TOWN OF WINTER PARK PLANNING COMMISSION Tuesday, January 23, 2024 8:00 AM

a. PUBLIC HEARING: Major Site Plan – Lions Gate Condominiums – 365 Lions Gate Drive (PLN22-078)

Minor Site Plan – 23 Maple Road – Amended Lot 4, Block 4, Winter Park Village Subdivision

RE PUBLIC HEARING: Major Site Plan – Lions Gate Condominiums – 365

SITE PHOTOMETRIC PLAN E1.0

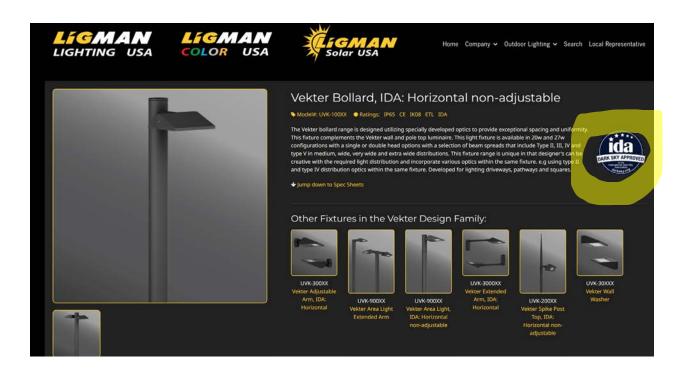
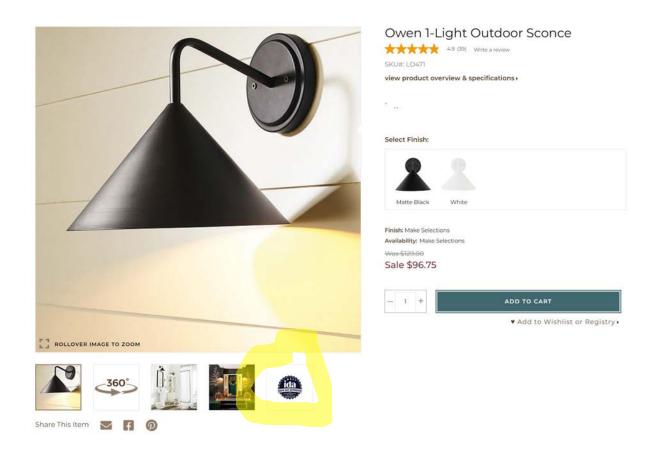
Partially satisfactory. The Applicant has revised their lighting proposal and is working on submitting an updated Photometric Plan, which staff will review upon receipt.

The BUG rating cannot exceed B1, U0, and G1. Both building and parking fixtures shall not exceed the height of the eave line, parapet wall, or fourteen feet (14'), whichever is less; heights comply. The Property is limited to 25,000 lumens (25,000 lumens per net acre plus 2,000 lumens for each additional acre beyond the first). The number of lumens will be analyzed upon receipt of an updated Photometric Plan.

Applicant shall submit a revised Photometric Plan for staff's review.
